# Intel<sup>®</sup> 80219 General Purpose PCI Processor

## Specification Update

Document Number: **274020-002**

**Figure 2. Intel® 80219 General Purpose PCI Processor P\_BMI Signal Implementation for Intel® 80219 General Purpose PCI Processor B-0/B-1 Stepping**

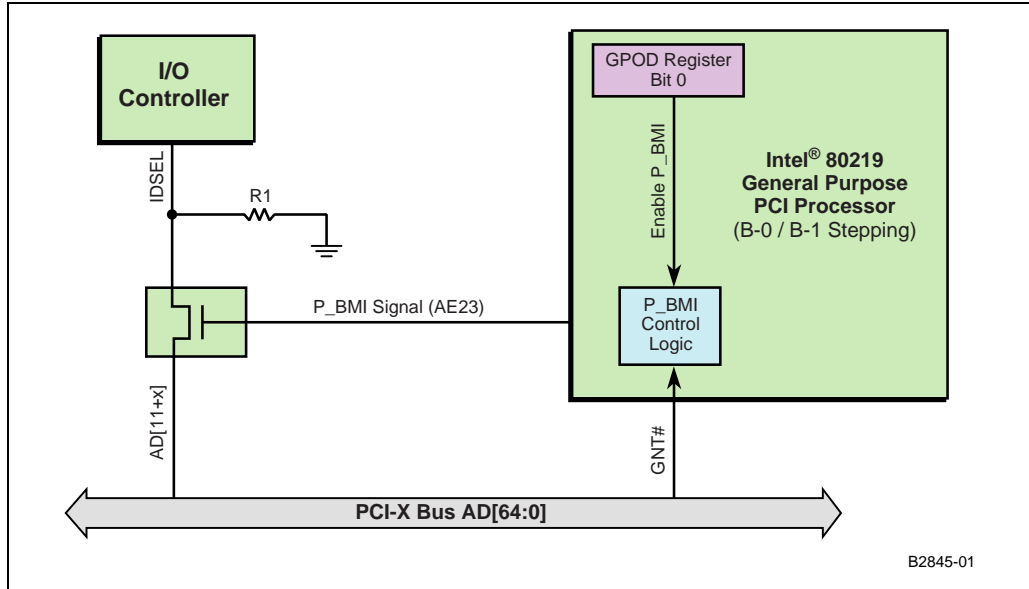
## 1. Signal NC2 was renamed to P\_BMI (AE23). New function added to signal P\_BMI.

The P\_BMI (AE23) signal has been added to the Intel® 80219 general purpose PCI processor. This signal replaces, using an external GPIO pin for Initialization Device Select (IDSEL) control of an I/O device during host configuration cycles.

The 80219 has eight integrated General Purpose Input Output (GPIO) pins, referred to as GPIO[7:0]. These pins, along with the new PCI-X Bus Master Indicator (P\_BMI) signal, can be used to control the IDSEL to the I/O device. External circuitry is no longer required other than a simple switch. The output function of the P\_BMI signal is controlled by the GPIO Output Data Register (GPOD), Bit 0 as shown in Table 1. The P\_BMI signal is always driven and defaults to driving low at power up.

The IDSEL signal is used as a chip select during configuration cycles initiated by the BIOS, operating system or 80219. The GPOD[0] can be driven low in firmware, thereby disabling the P\_BMI signal and hiding the host I/O device from the system, by turning off its IDSEL. When the 80219 intends to perform configuration cycles in the PCI bus segment of the I/O device, the P\_BMI signal should be asserted high by driving the GPOD[0] high. The affect of these two operations is, that the I/O device is initialized and controlled by the 80219. More care must be taken with the gate chosen to control IDSEL, since most host bridge controllers do not use PCI address stepping. With IDSEL being a synchronous signal, with respect to CLK, the switch used must be a sub nanosecond propagation delay device (e.g., Pericom PI5C3303). In Figure 2, the P\_BMI signal is used to control a MUX/DeMUX switch that is used to enable/disable IDSEL to the I/O device.
